ZS-2015-0172

Zion Nuclear Power Station, Units 1 and 2
Facility Operating License Nos. DPR-39 and DPR-48
NRC Docket Nos. 50-295, 50-304 and 72-1037

**Subject: License Amendment Request for Proposed Revision to Zion Nuclear Power Station
Defueled Station Emergency Plan**

FIGURE 2-1
ZION STATION ISFSI

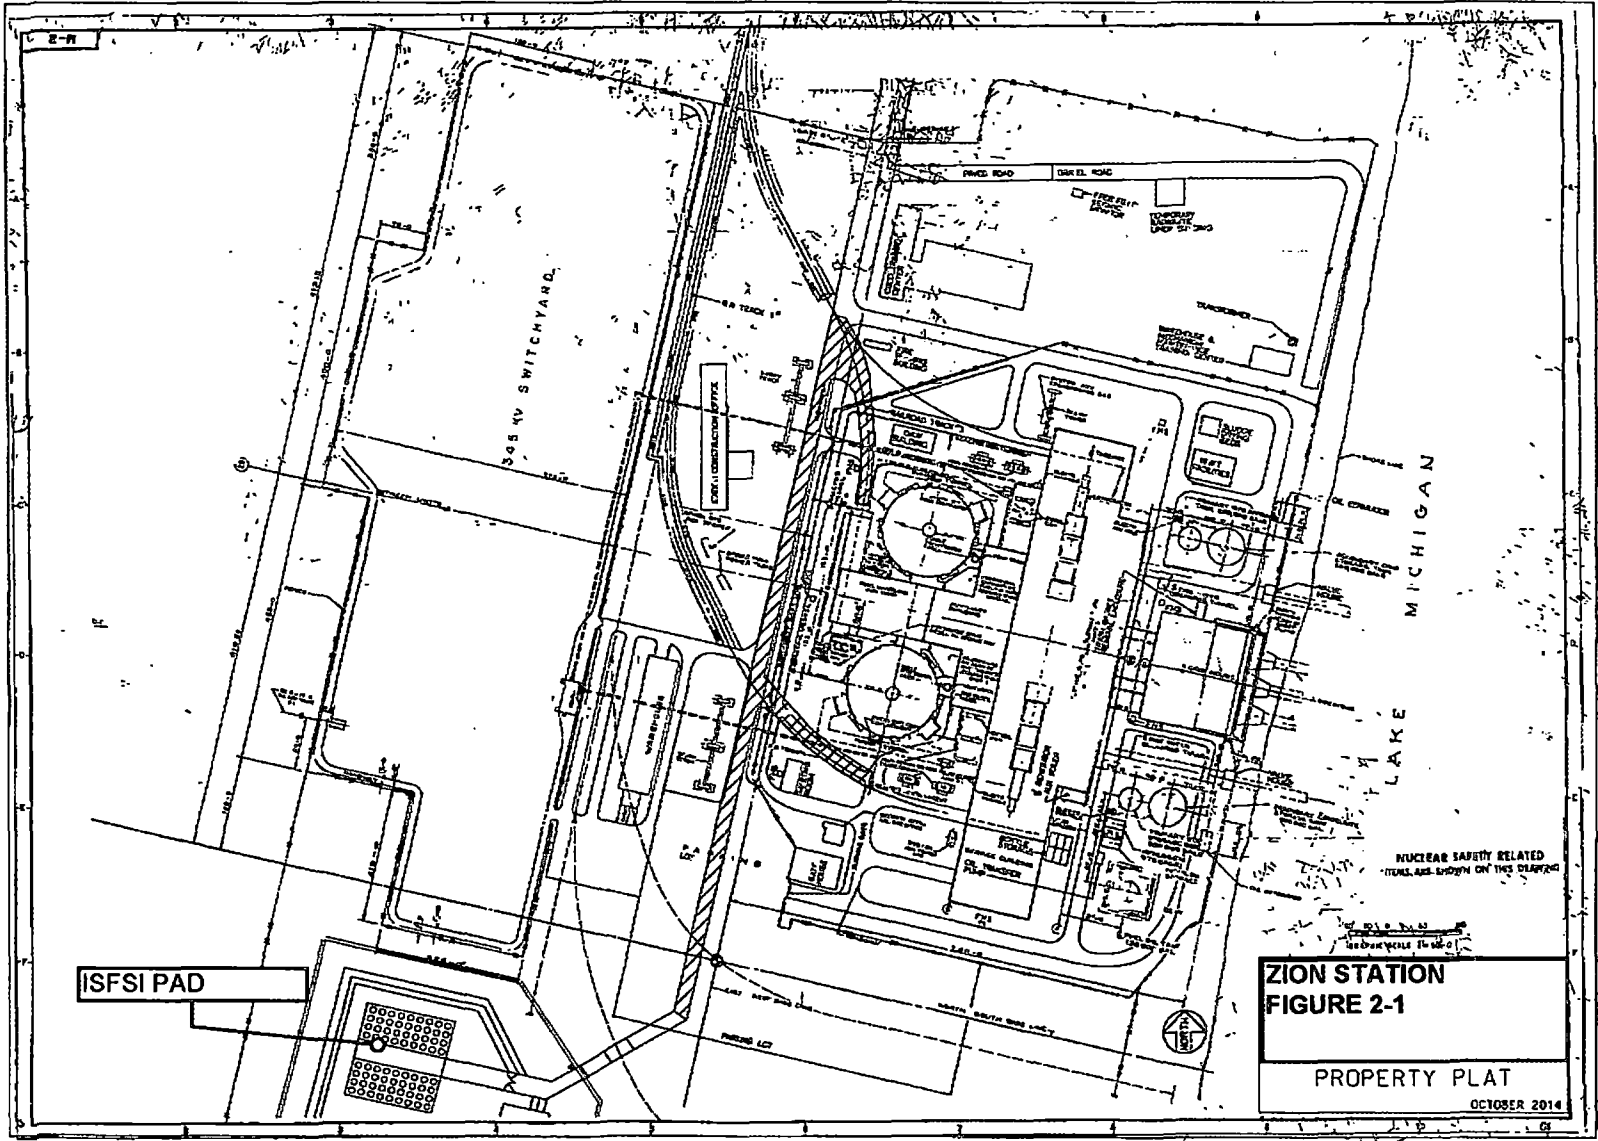
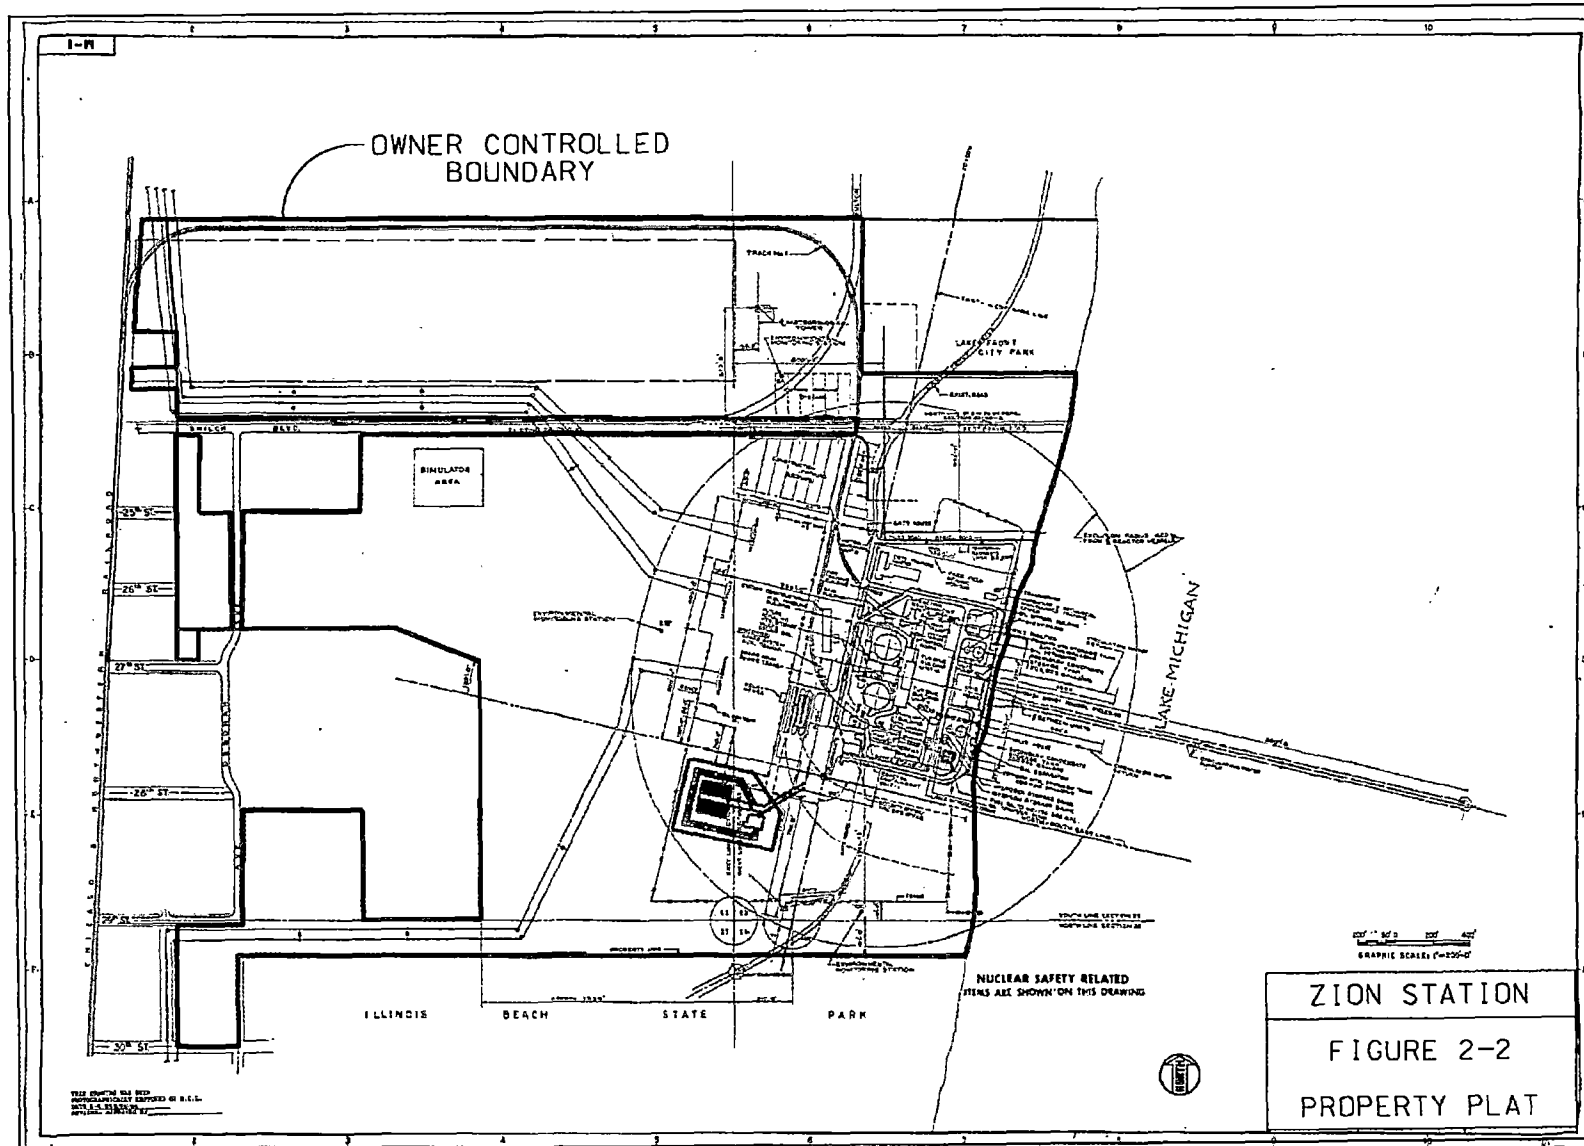
Section 2.0, Facility Description: This section was revised to address only the ISFSI by deleting part of Sub-Section 2.1 (Site) and all of Sub-Section 2.3 (Zion Nuclear Power Station) which described the site (other than the ISFSI). Figure 2-1, "Zion Station Owner Controlled Boundary" and Figure 2-2, "Zion Station Owner Controlled Boundary" were added. Minor editorial changes were made in Sub-Section 2.3 (Independent Spent fuel Storage Installation).

FIGURE 7.1
EMERGENCY RESPONSE ORGANIZATION

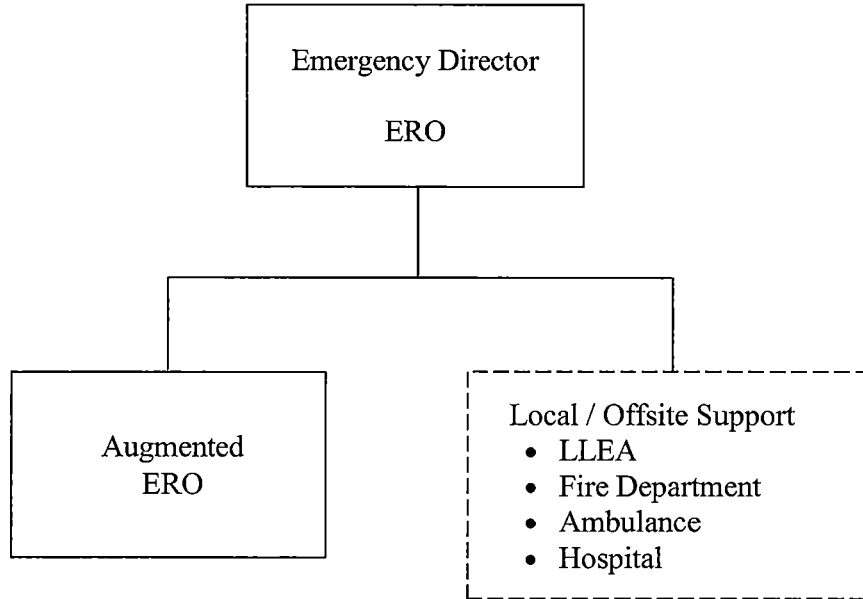
Sub-Section 7.3.1 (On-Shift Radiation Protection Personnel) was deleted since the On-Shift Radiation Protection Personnel can be replaced by On-call support personnel. Figure 7.1 (Emergency Response Organization) was changed to eliminate the block containing On-Shift Radiation Protection since this function will be transferred to Offsite support personnel.
